**CITY OF MERIDIAN
FINDINGS OF FACT, CONCLUSIONS OF LAW
AND DECISION & ORDER**

Case No(s). H-2021-0071

STAFF REPORT

SUBJECT: H-2021-0071
Lennon Pointe Community

C. Open Space Exhibit (date: ~~9/13/2021~~) Revised January 2022

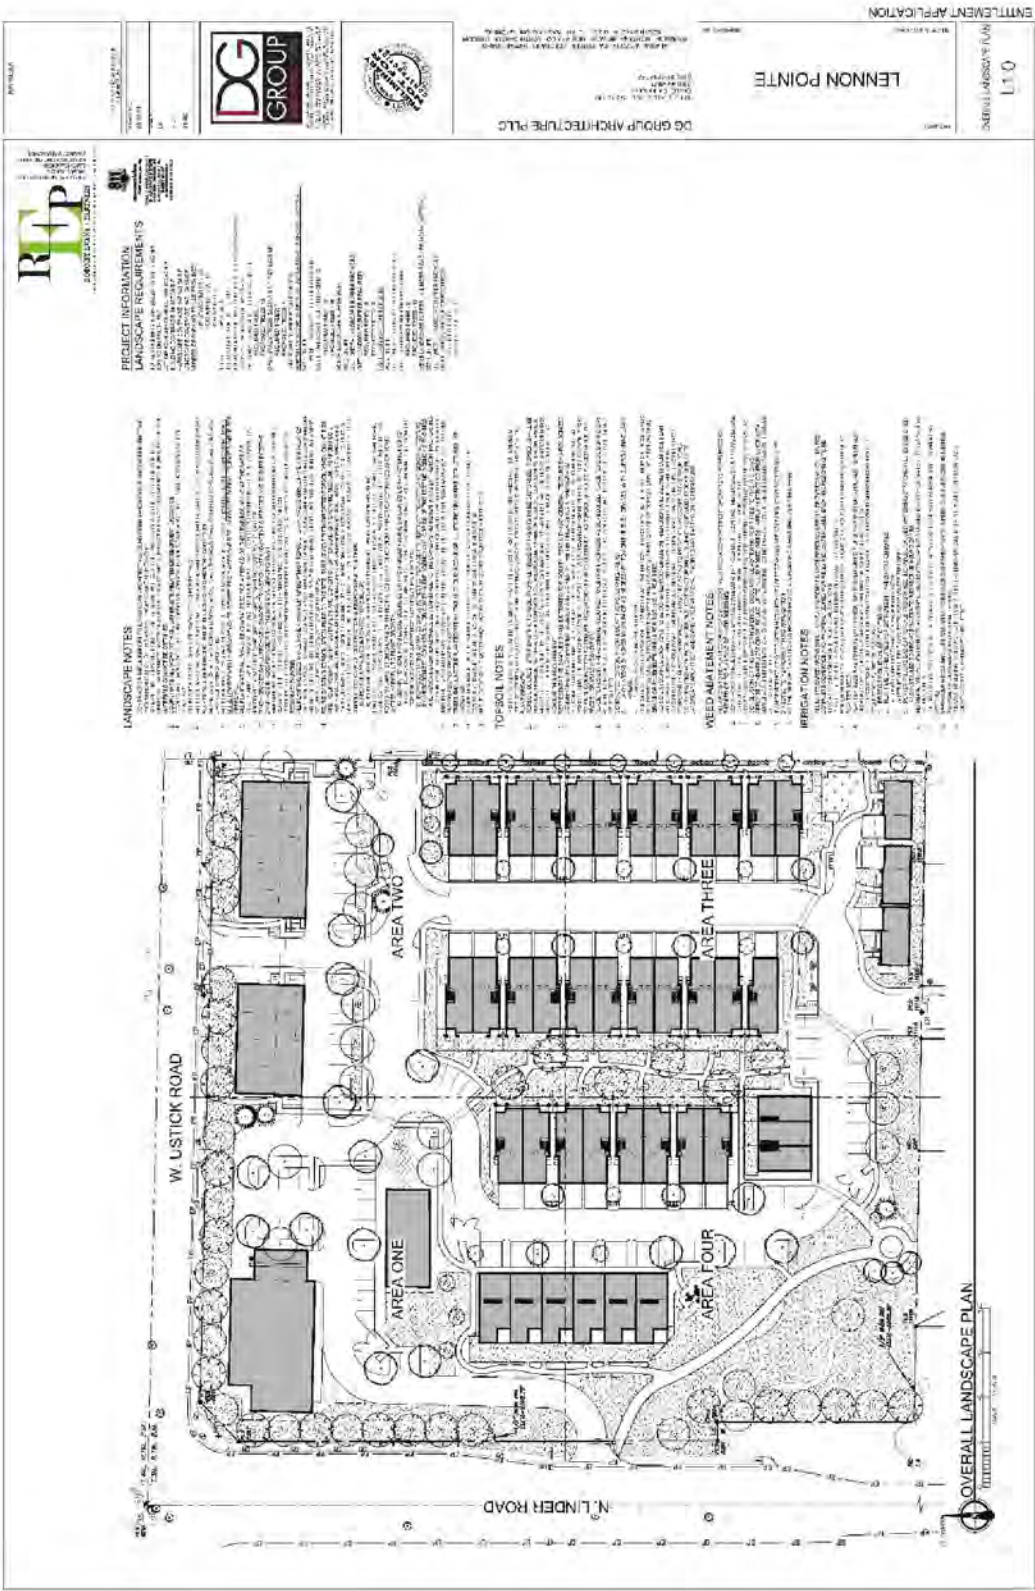
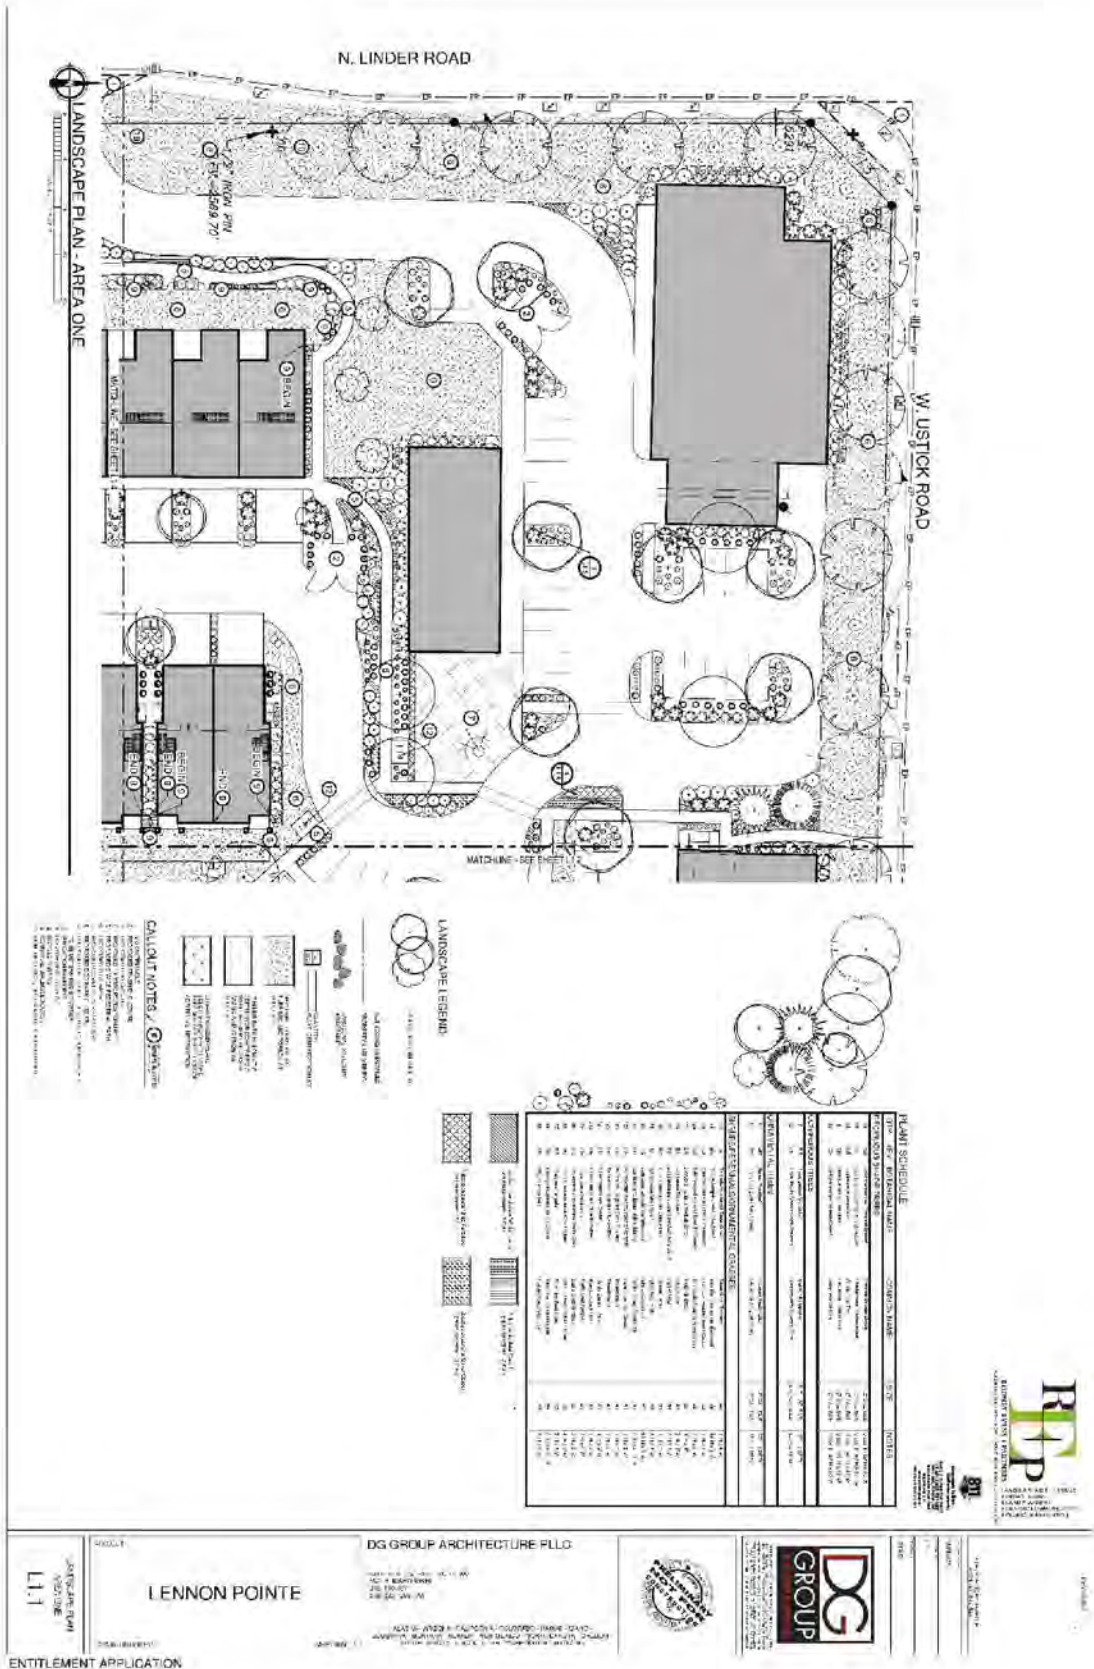
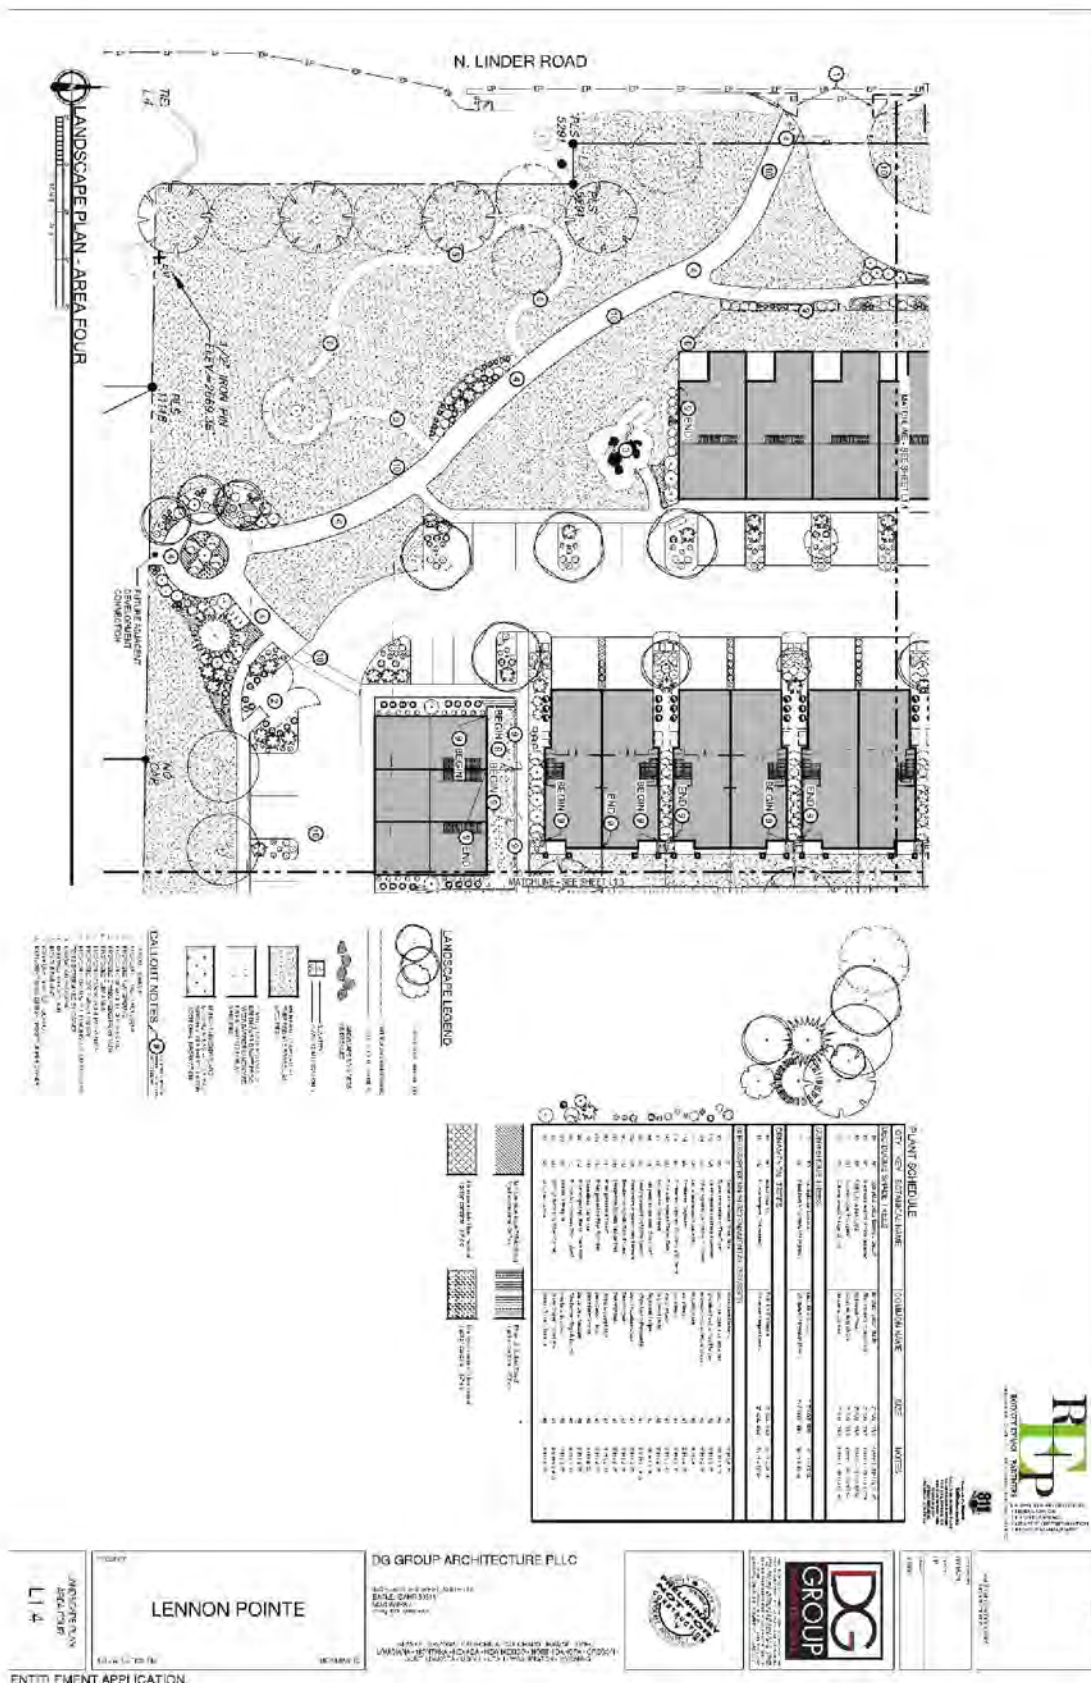
The Applicant has revised the open space exhibit per Staff's request to depict the qualified areas and accurately note the amount of qualified open space for the project. According to the revised exhibit, the Applicant is proposing 1.64 acres of qualified open space, approximately 18.7%. The majority of the qualified open space consists of the large open space area in the southwest corner of the site, the large central mew, and half of the required arterial street buffers. This area exceeds the minimum UDC requirements.

D. Landscape Plans (date: 9/15/2021) NOT APPROVED (requires revision prior to Final Plat)

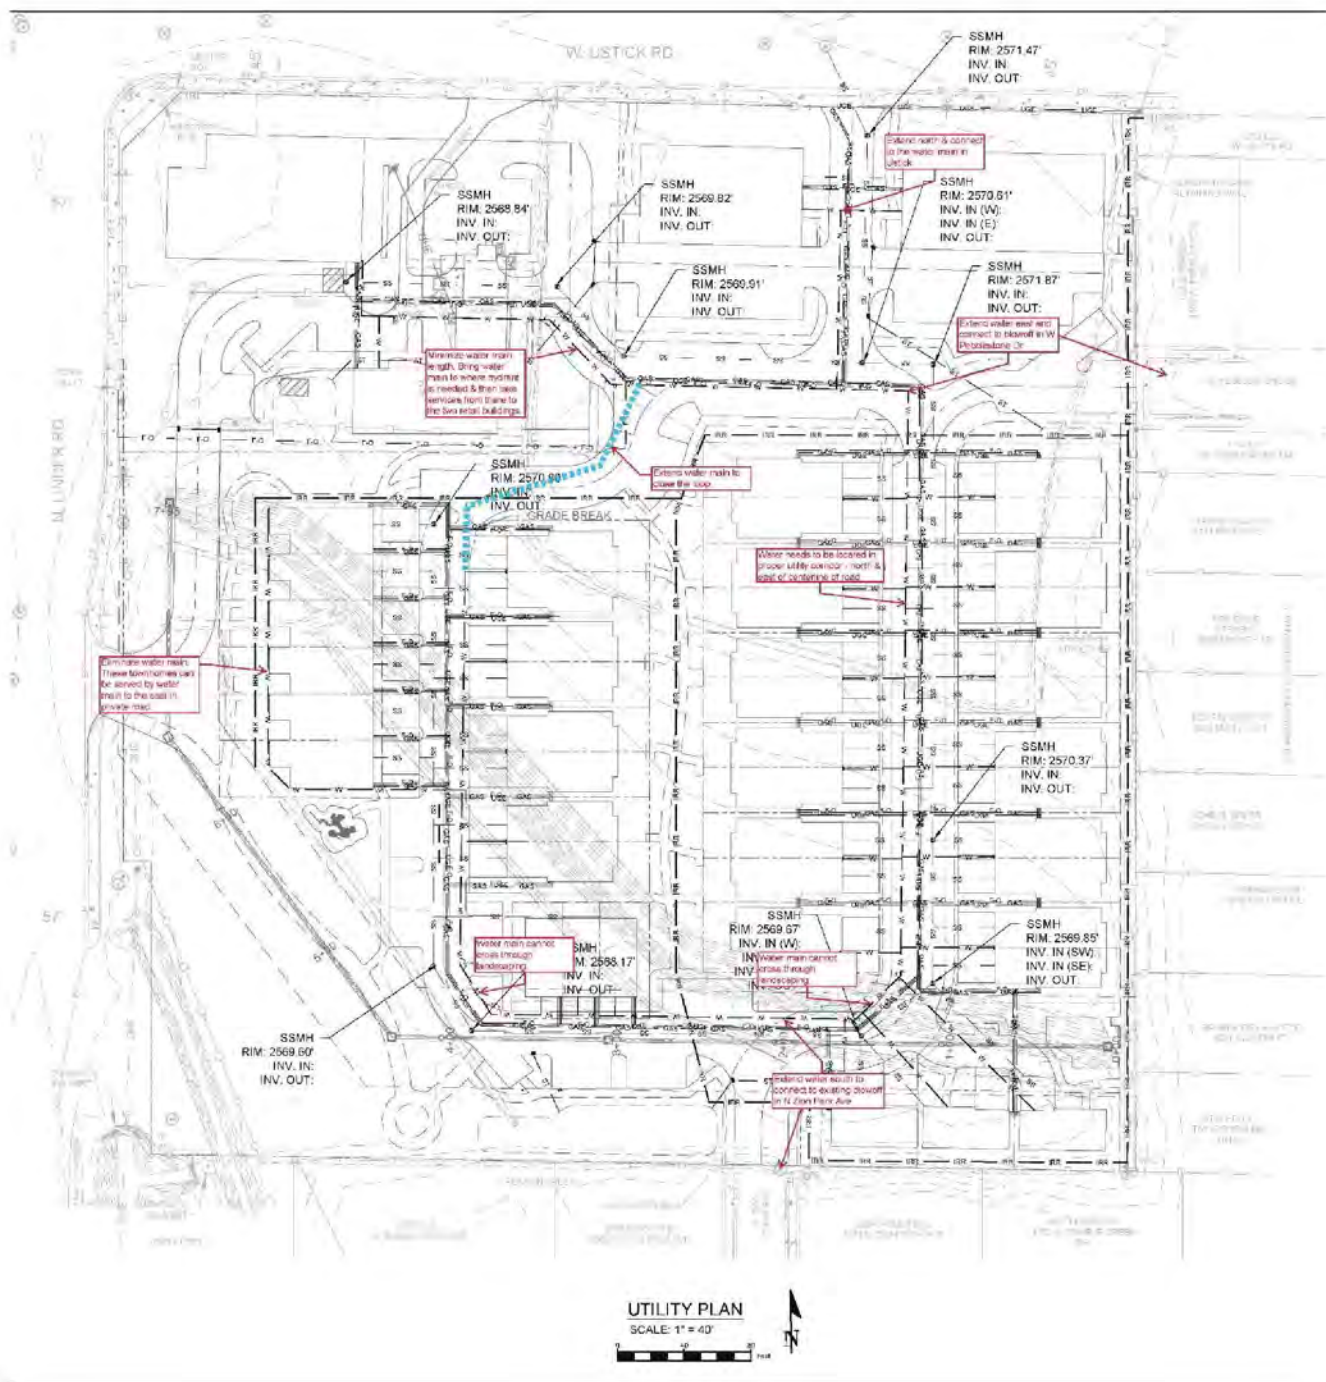
According to the submitted landscape plans, the proposed regional pathway in the southwest corner of the site is also within the Kellogg Drain irrigation easement which generally does not allow trees and minimal landscaping. The submitted landscape plans show no trees proposed within this easement.

3. The landscape plan included in Section VII.D, dated September 15, 2021, shall be revised as follows prior to submittal of the Final Plat application:

- a. Revise the location of the trees for the Linder Road street buffer to be outside of any waterway easement.
 - b. Shift the proposed regional pathway on Lot 1, Block 1 to the west to better align with the approved segment to the south in Creason Creek No. 2.

- c. Show the required 25-foot landscape buffer between the C-C zoning district and the R-15 zoning district as required by UDC 11-3B-9C.
 - d. Revise the landscape plan to match the revised preliminary plat and site plan dated January 2022.

F. Public Works – Water Markup

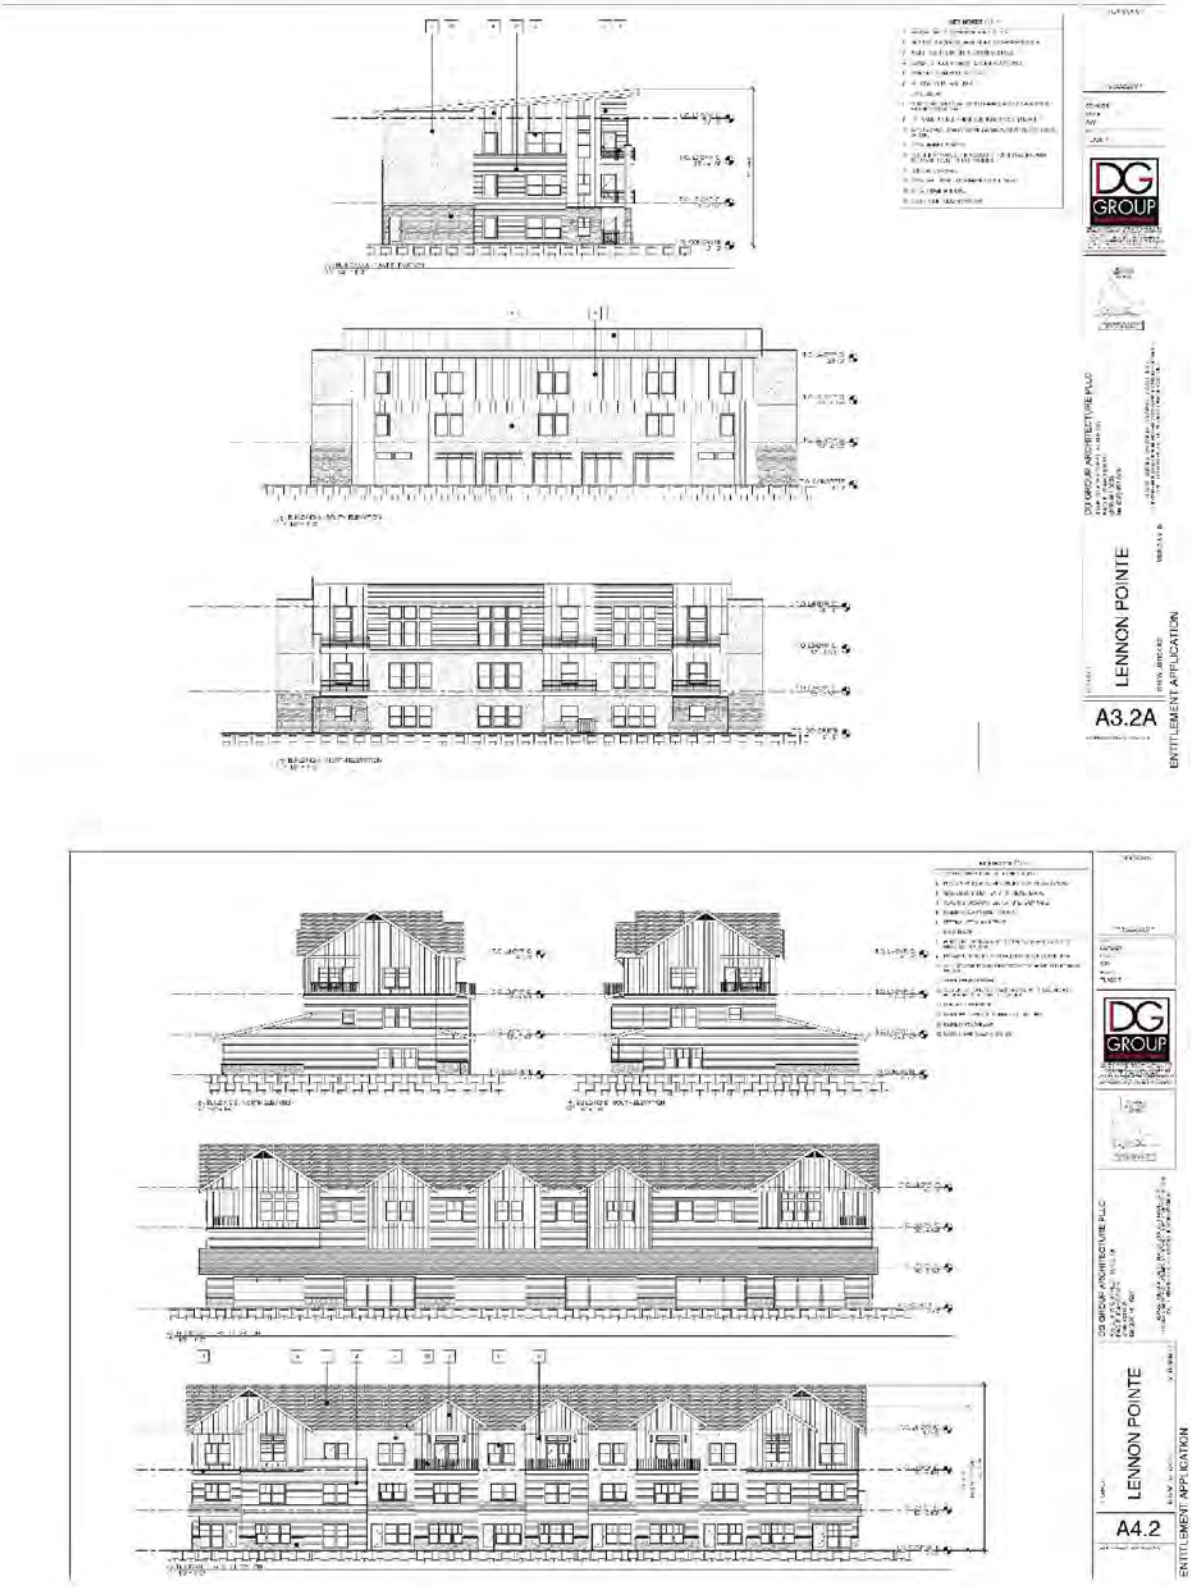
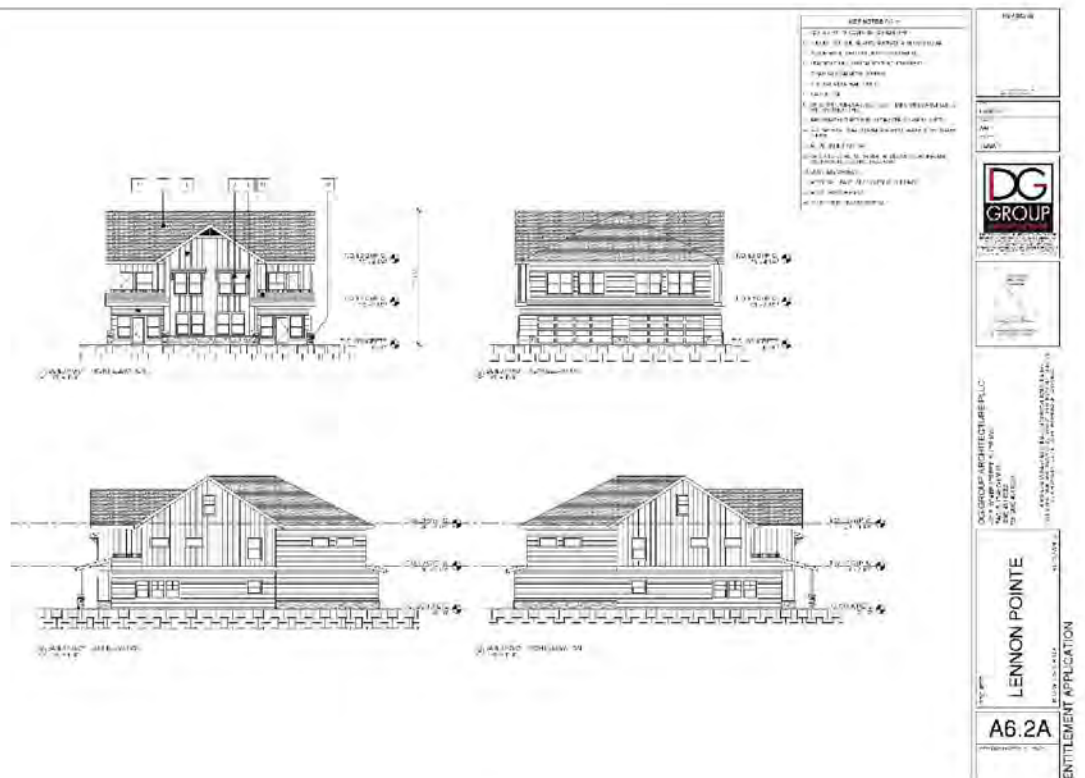
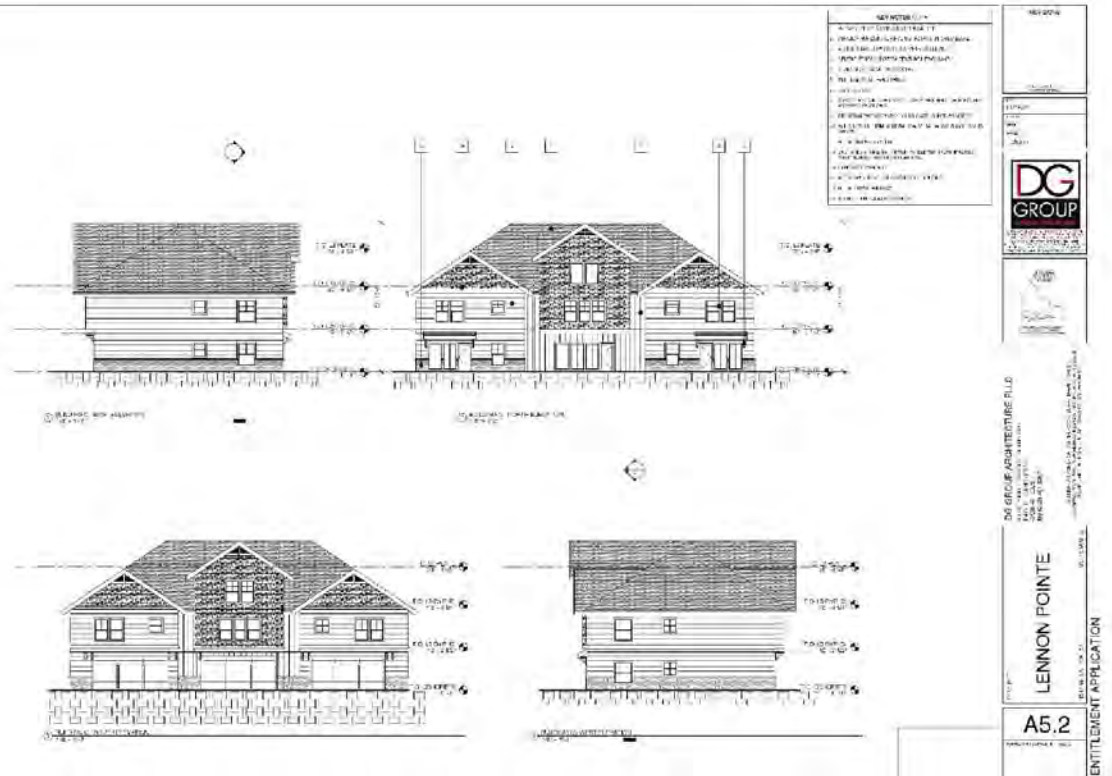
8. Minimize water main length near the commercial lot at the northwest corner of the development. Bring the water main only as far as needed to provide a hydrant for the buildings' fire protection. Extend service lines from the main to serve the two retail buildings.
